## **8.0 CULTURAL RESOURCES COMMENTS AND RESPONSE**

Salem Hunt

Town of North Salem, Westchester, New York

Figure 8-1: Pole Mounted Lighting Detail

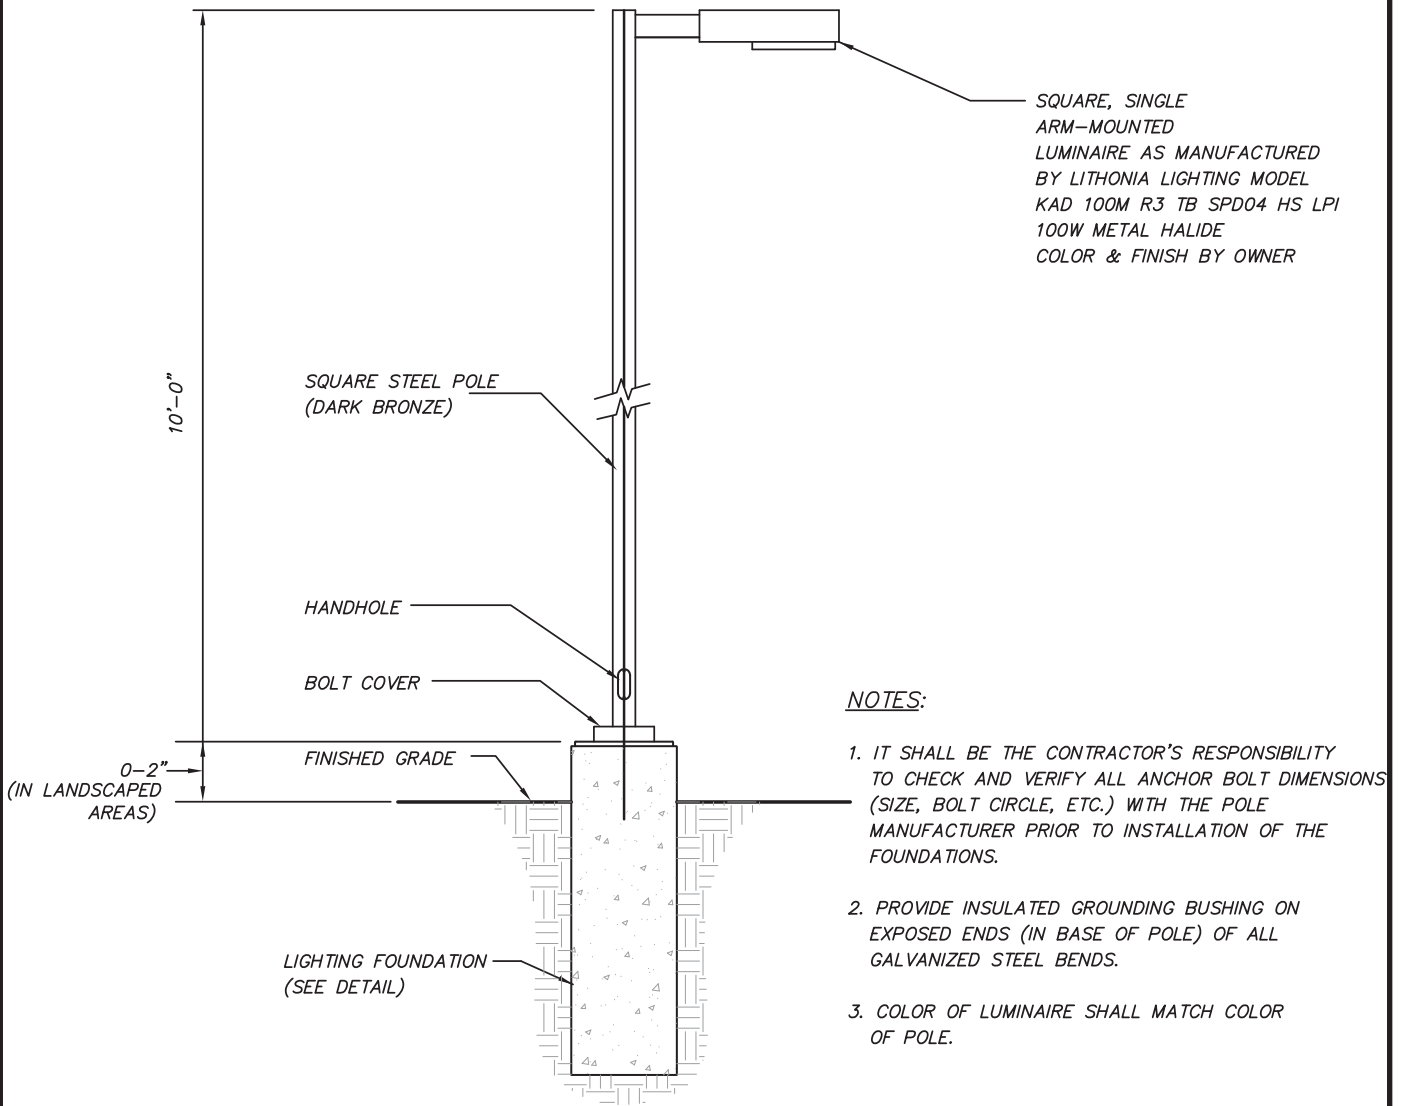
**Comment 8-1 (Chairwoman Curtis, Public Hearing, June 11, 2008):** There are some -- I think lighting is an important issue in the Town of North Salem, and -- there's some exterior lighting along the roads as being proposed. I would like to see an analysis of some sky glow issues and maybe some redesigning of the lighting.

- The proposed 14 foot high standard is too tall; a lower height should be utilized throughout the site (10 feet should be adequate).
- The linear placement of street lighting along the entrance roadway should be eliminated. Roadway lighting should be limited to intersections and to areas where visitors utilizing the visitor parking spaces may cross the roadways.
- Lighting for common areas should be specific to the use and frequency.
- Limitations should be proposed (e.g, restricted hours, timers, motion detectors, etc).

**Response 8-1:** *The lighting along the proposed roads for the Salem Hunt project and the concern about sky glow were considered in the redesign of the Lighting Plan included with this FEIS (see enclosed plans, sheet LP-1). The plans originally submitted with the accepted DEIS included roadway lighting consisting of thirty-seven (37) 150-watt metal halide antique style street lamps, pole-mounted at 14 feet in height. The plans have been redesigned to significantly reduce the roadway lighting proposed to three (3) 100-watt metal halide street lamps, pole-mounted at 10 feet in height; and fifteen (15) 70-watt metal halide bollard lamps at 3 feet 6 inches in height. The number of pole-mounted lights is substantially reduced from 37 lamps to only 3 lamps. The total number of lamps is reduced by half; the wattage of all of the lamps is reduced by one-third or one-half; the height of the pole-mounted lights is reduced to 10 feet in height; and the bollard lights are approximately waist high. The revised lighting and the related photometric contours are provided on the Lighting Plan (sheet LP-1). A detail of the pole mounted light is provided as Figure 8-1 Pole Mounted Lighting Detail and a bollard light is shown in Figure 8-2 Bollard Light Detail.*

**Response 8-2:** As described in response to Comment 8-1, above, the Lighting Plan has been redesigned to significantly reduce the roadway lighting proposed to three (3) 100-watt metal halide street lamps, pole-mounted at 10 feet in height; and fifteen (15) 70-watt metal halide bollard lamps at 3 feet 6 inches in height (see Figures 8-1 and 8-2). The total number of lamps is reduced by half; the wattage of all of the individual lamps is reduced by one-third or one-half; the height of the pole-mounted lights is reduced to 10 feet in height; and the bollard lights are approximately waist high.

The pole-mounted lighting along the entrance roadway has been eliminated. The three 10-foot high pole-mounted lights are located at two internal intersections and a common parking area only and bollard lights are proposed at smaller common parking areas; at a turnaround area; and around the pool.
